MIL-M-28787/270(EC)
AMENDMENT 2
30 October 1984
SUPERSEDING
AMENDMENT 1
5 February 1980

MODULES, STANDARD ELECTRONIC

RELAY, ANALOG, KEY CODE ZRY

FIGURE 9. Turn-on and turn-off delay time test circuit waveforms for table VII.

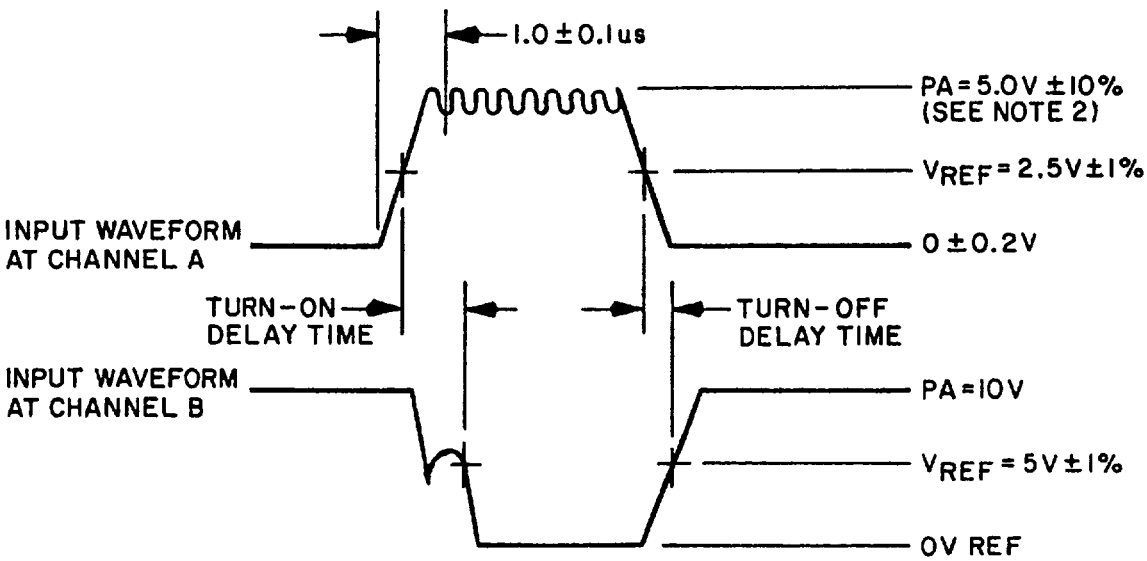
FIGURE 9: Delete and substitute new figure 9 as printed on page 2 of this amendmentment.

NOTES:
1. Turn-on delay time is measured to where the channel B voltage goes to the 5 V level and thereafter remains below 5 V until the turn-off command is given.
2. The 5.0 V ±10% level of the input pulse is measured at the center of the ripple 1.0 ±0.1 µs from the start of the trace.
